ATTACHMENT 4: UPDATE TO S. 3.4.1.3 REGARDING LOCATION OF REPEATER STATIONS

Section 3.4.1.3, page 3-22, paragraphs 2-4 of the Bipole III EIS discusses four repeater stations and their anticipated locations. Since filing the EIS, design has progressed and more specifics related to the number and location of the repeater stations are available. Hence, the following paragraph updates the information in section 3.4.1.3.

Bipole III Transmission Project

Fibre Optic Repeater Sites
 Bipole III Transmission Project

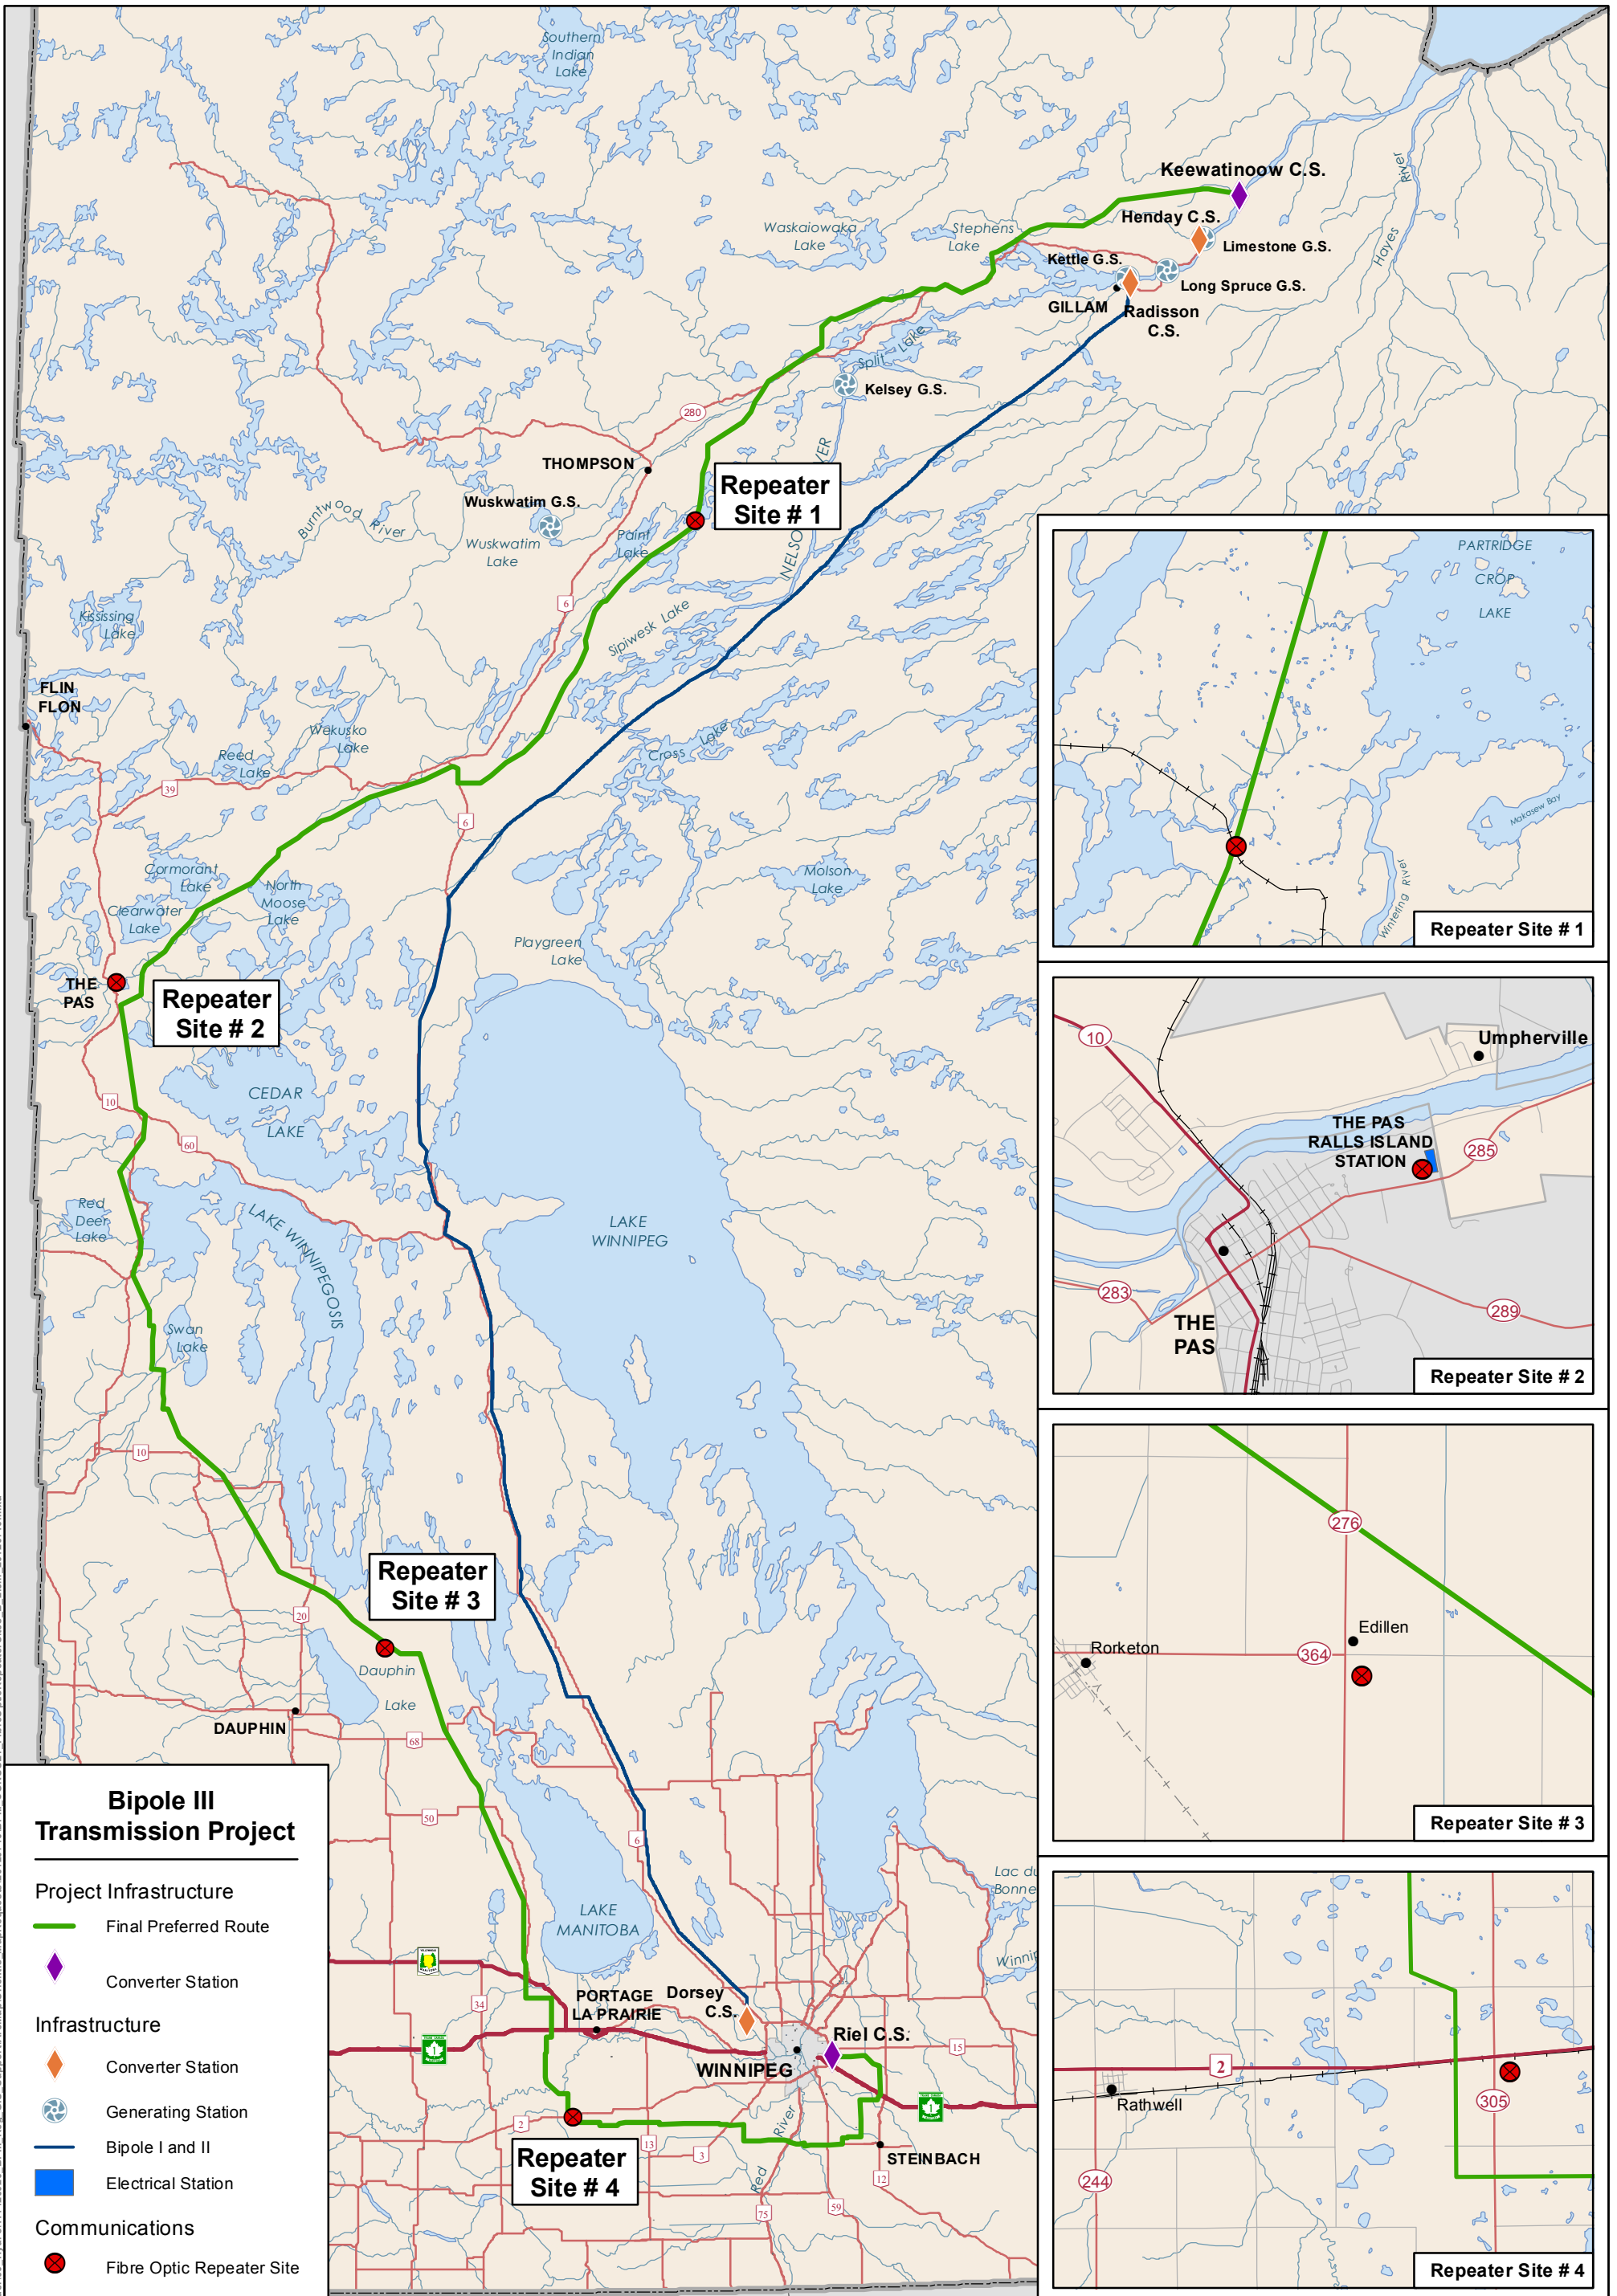
Four repeater stations will be required for the Bipole III project. The following Map, entitled “Fiber Optic Repeater Sites” denotes the anticipated locations of each of the repeater stations. Of the four, one station will be located within the confines of an existing transmission facility and the other three will be newly constructed on or adjacent to the Bipole III right of way. One repeater station (the 2nd repeater station along the route) will be housed at the Pas-Ralls Island transmission station, in order to take advantage of existing communications facilities. The remaining three repeater sites will be housed in yet to be developed or new stand-alone sites located within the HVDC line right-of-way, and within 100m to 300m of a transmission tower. The first of these three will be located in the southeast quarter of Section 4 Township 76, Range 1, west of the prime meridian, between Keewatinoow (about 290 km distant along the right-of-way from Keewatinoow) and The Pas-Rauls Island transmission station. The site is near Partridge Crop Lake, roughly 30 km southeast of Thompson. The second new site will be located at the existing Manitoba Hydro Rorketon Station, located at North West quarter of Section 9, Township 28, range 15 west of the prime meridian. The third stand alone site will be located on Municipal land in the southwest corner of Section 13, Township 8, Range 8, west of the prime meridian, about 238 km distant from the second stand alone site. This third stand alone site is located east of the town of Rathwell.
